To: Bill Huffman (NRC)
 cc: B. McIntyre (Informal NRC File), Larry Hochreiter (Fax), Bob Osterrieder,
 Mike Young, Andy Gagnon, Dan Garner, Bob Kemper, File 7.6
 Subject: NOTRUMP & WC/T
 Date: February 7, 1997
 Pages: ~~Two~~, including this cover sheet.
Three

OPEN ITEM #172 (M5.2.5-29)

AP600 Open Item Tracking System Database: Executive Summary

7.2-1 sheet 12

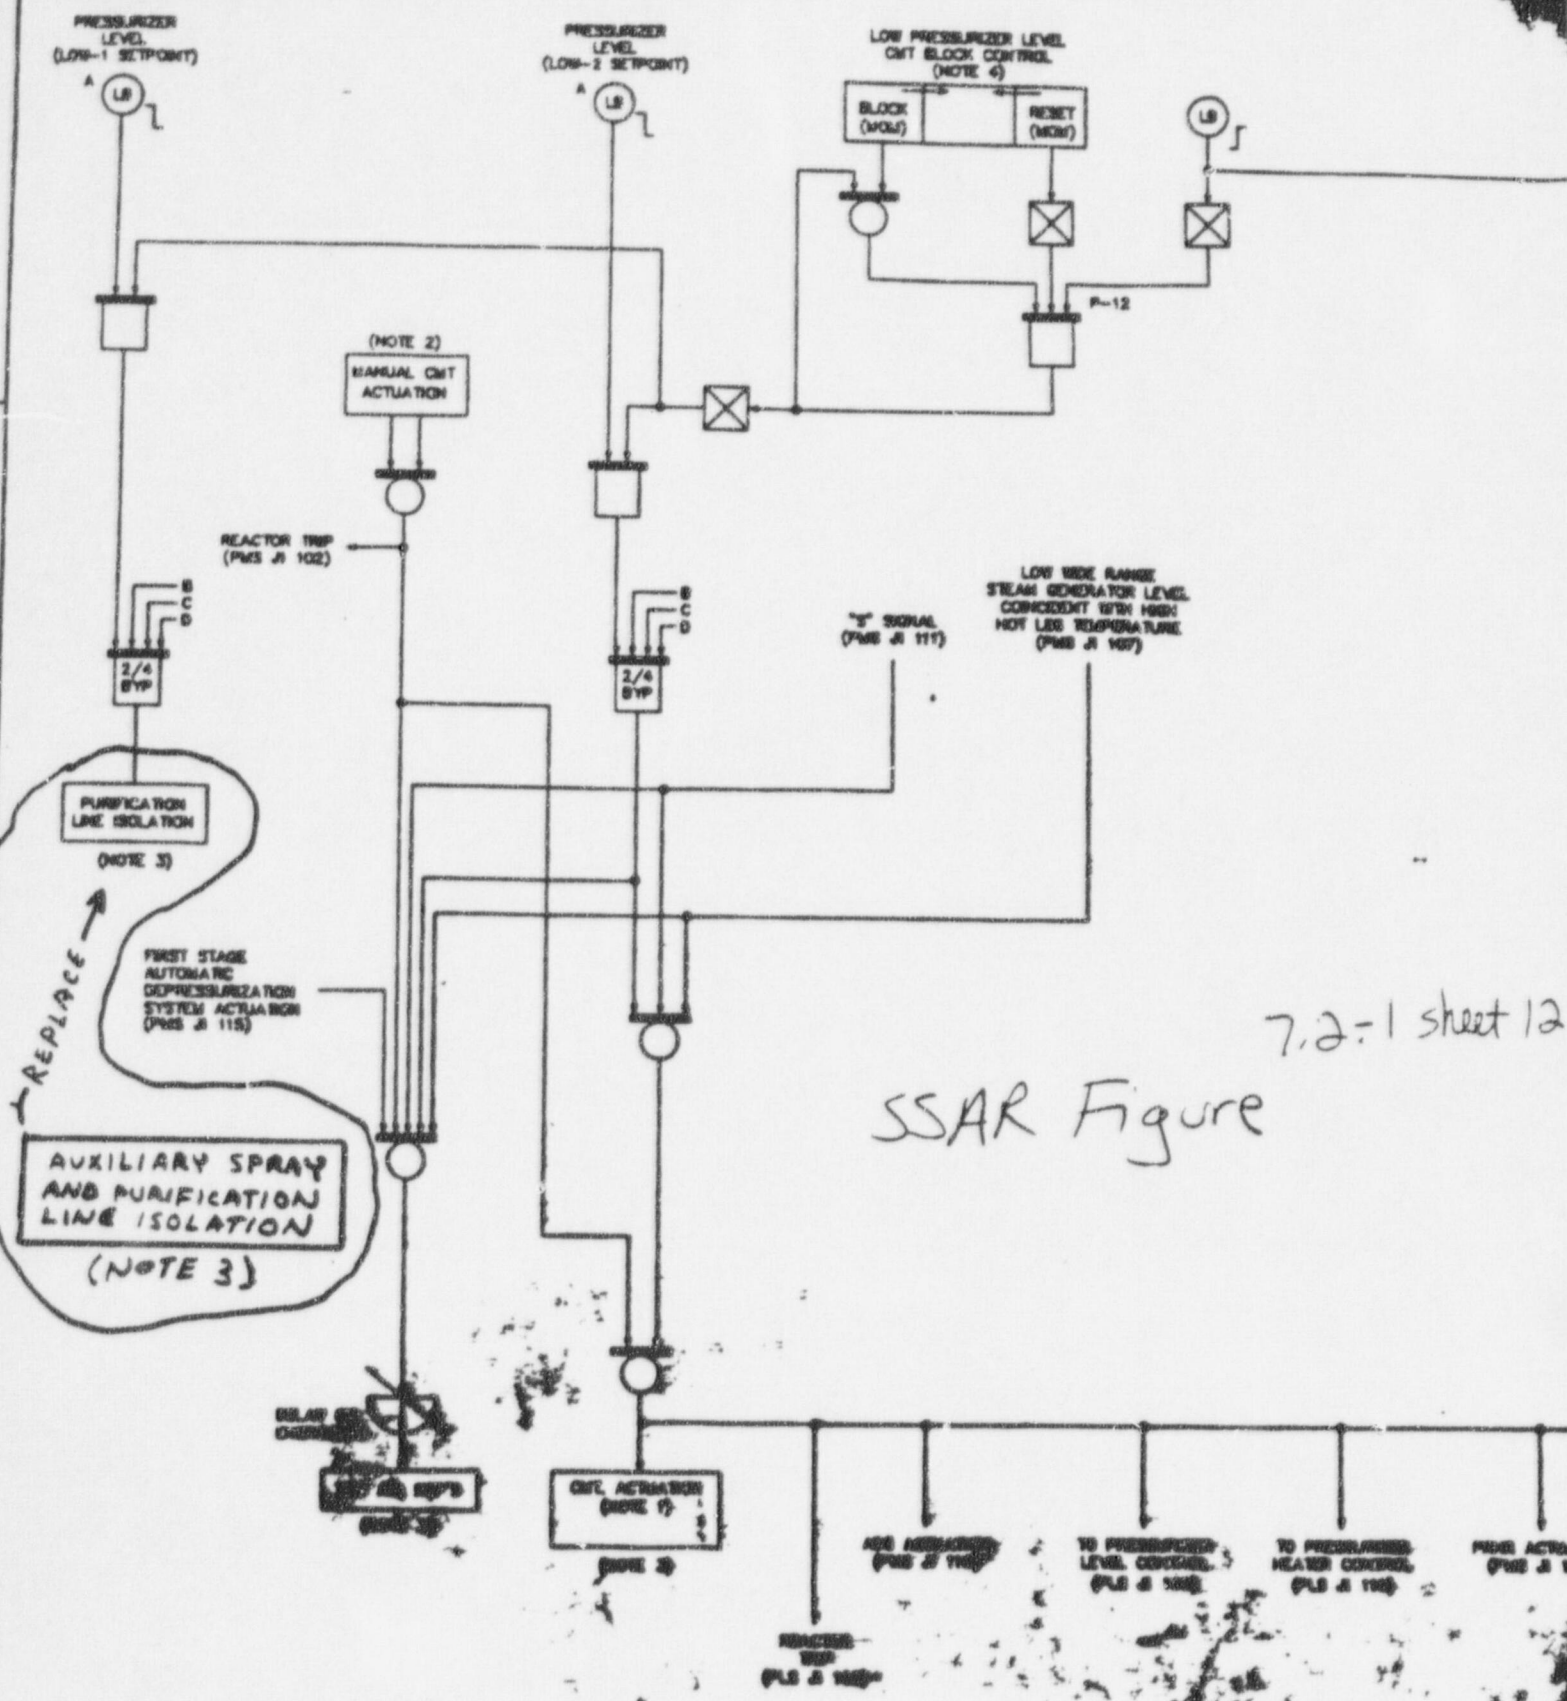
A signal to isolate the *auxiliary spray and* letdown purification lines is generated upon the coincidence of pressurizer level below the Low-1 setpoint in any two of four divisions. This helps to maintain reactor coolant system inventory. This function can be manually blocked when the pressurizer water level is below the P-12 setpoint. This function is automatically unblocked when the pressurizer water level is above the P-12 setpoint. The functional logic relating to this is illustrated in Figure 7.2-1, sheet 12.

17. Purification Line Isolation (Figure 7.2-1, Sheet 12)			
a. Low-1 pressurizer level	4	2/4-BYP ¹	Manual block permitted below P-12. Automatically unblocked above P-12.

NO. 1	5
REV. 01	REV. 01
APR-300	APR-300
LOH-87923	LOH-87923
098-883-418 REV 1	098-883-418 REV 1
ADDED PRESS LEVEL	ADDED PRESS LEVEL
LOW-1 SETPOINT	LOW-1 SETPOINT
LOGIC	LOGIC
RELOCATED PURIF	RELOCATED PURIF
LINE ISOLATION	LINE ISOLATION
OTMADA 8-18-88	OTMADA 8-18-88
F. DeLoe	F. DeLoe
2. DeLoe	2. DeLoe

Figure 7.2-1 (Sheet 13 of 20)

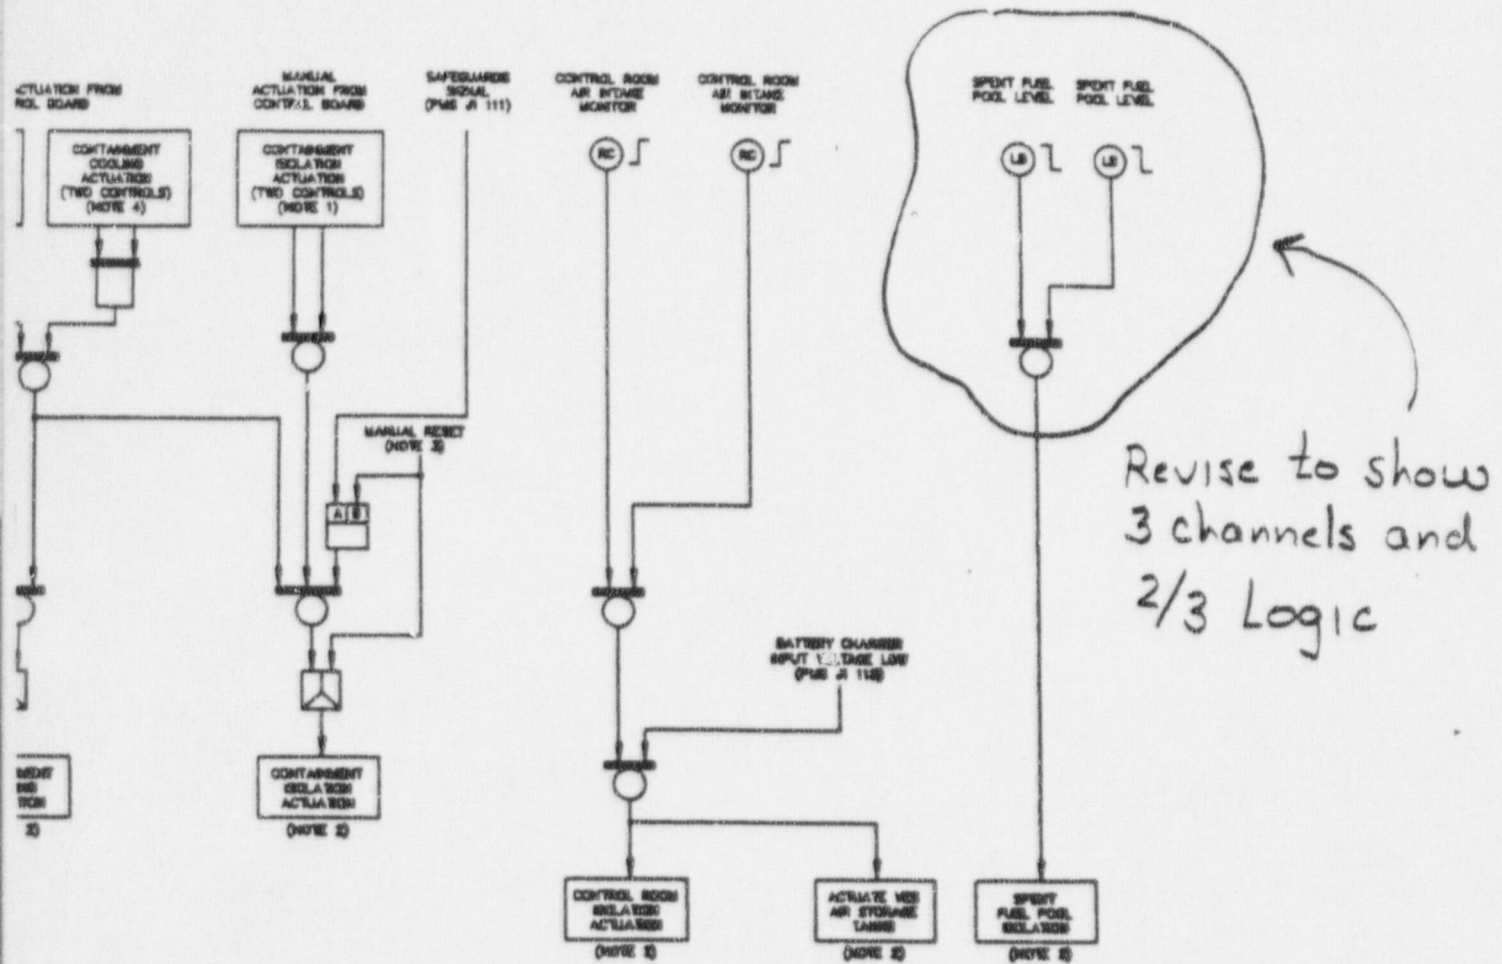
A signal for isolating the spent fuel pool lines is generated upon the coincidence of spent fuel pool level below the Low setpoint in ^{two} ~~any one~~ ^{three} ~~of four~~ divisions. This helps to maintain the water inventory in the spent fuel pool due to line leakage. The functional logic relating to this is illustrated in Figure 7.2-1, sheet 13.

20. Spent Fuel Pool Isolation (Figure 7.2-1, Sheet 13)			
a. Low spent fuel pool level	2 3	1/2 2/3	None
21. Open In-Containment Refueling Water Storage Tank (IRWST) Injection Line Valves (Figure 7.2-1, Sheet 16)

Figure 5.1-5 (Sheet 1 of 3)
 Reactor Coolant System
 Containment Internal Structures
 Piping and Instrumentation Diagram

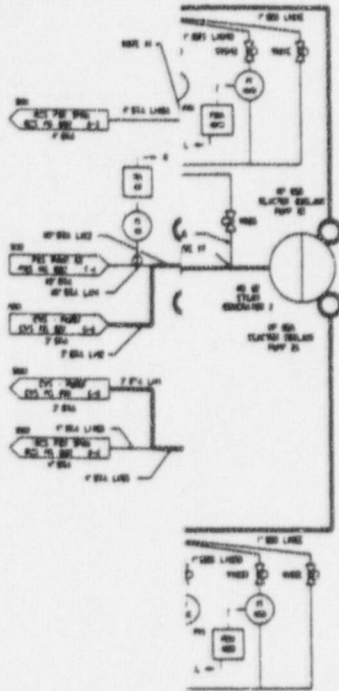
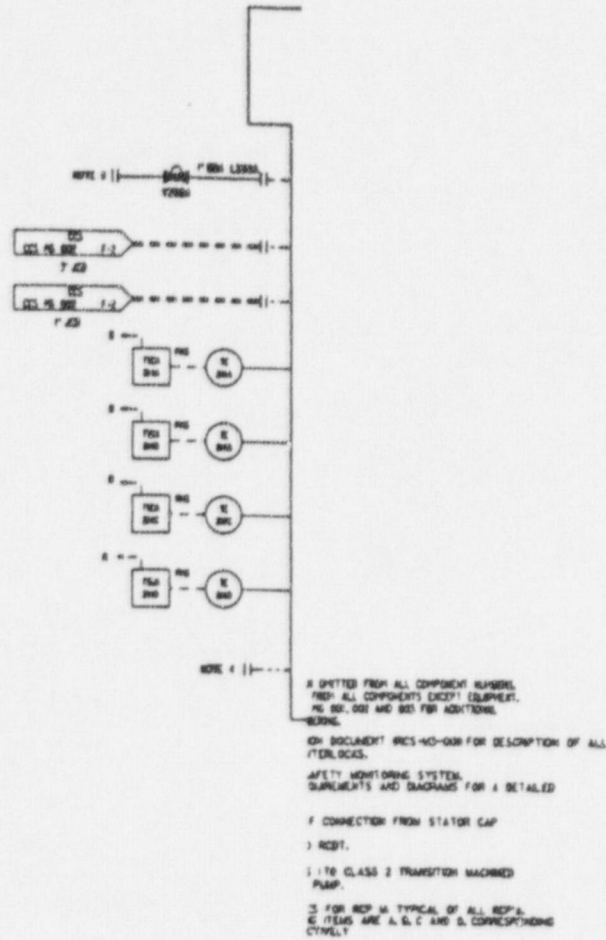
COMMENTS:
BILL
THIS MARKUP SHOULD RESOLVE OPEN ITEM 184 FROM OUR DECEMBER 2, 1996 TELECON. IT WILL BE IN SSAR REVISION 11 UNLESS WE HEAR FROM YOU. WE RECOMMEND THIS BE CHANGED TO "ACTION N" SINCE SPECIFIC REFERENCES ARE INCLUDED IN THIS FAX.
cc: BUTLER LINDSEY MCINTYRE CUMMINS ROBINSON WINTERS CORLETT SMITH JEANNE BURNS
<i>Jim Winters</i>
